# Product Change Notice

Date:	September 17, 2019
Overview:	A change has been made to the terminal box for 138 frame AC motors
Reason for Change:	Improved design due to updated tooling
Affected Part No(s):	Ø500 to Ø650 mm radial fans and Ø630 to Ø910 mm axial fans using an AC motor (1-phase / 3-phase) in size 138 (exact PNs listed on last page of this notice)
Design Change Detail:	The new terminal boxes are more robust and have an improved sealing system - the bottom part of the terminal box now has integrated sealing which eliminates the need for an O-ring. The overall height of the terminal box remains the same.
Effective Date:	Running change, effective immediately
Last Time Buy Deadline:	N/A
Pricing:	No change
ebm-papst employee:	Jeannine Zenobi
Attachments:	<ul style="list-style-type: none"> <li>Detailed comparisons, original vs new design</li> <li>List of specific PNs affected by this change</li> </ul>
Comments:	94 and 110 frame motors are also impacted (please see separate PCNs)

## AC Motor Size 138

# Comparision of Terminal Boxes

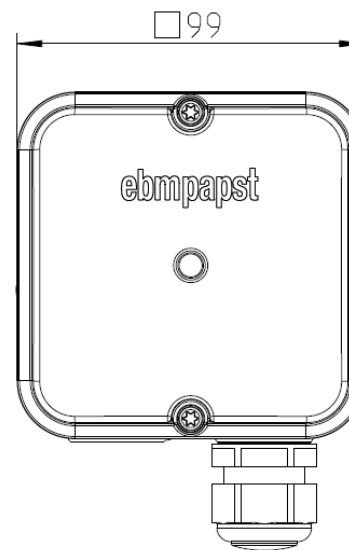
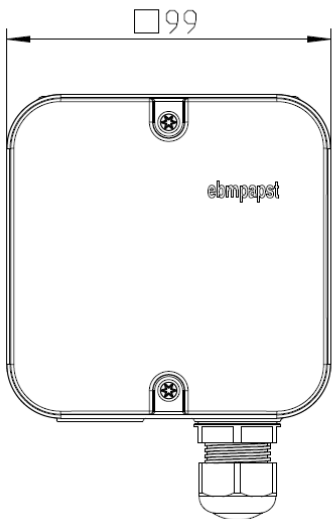
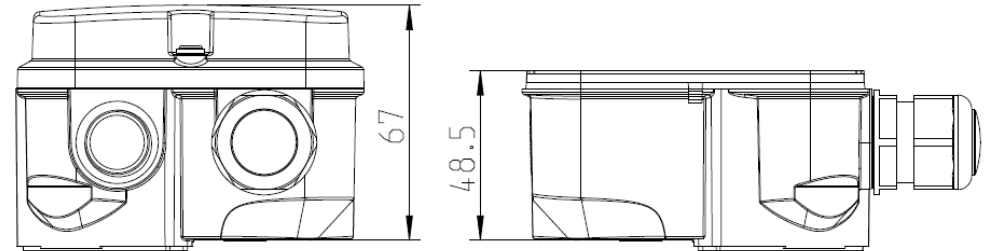
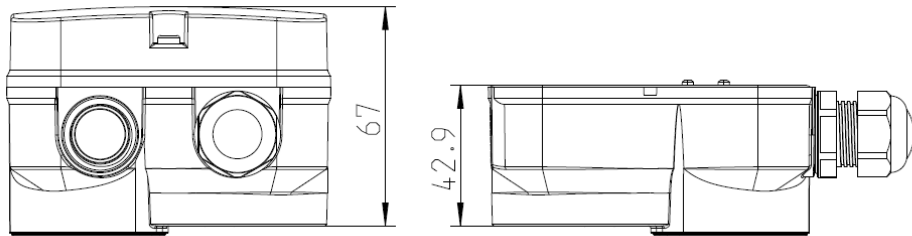
## Measurements

Original Terminal Box

New Terminal Box
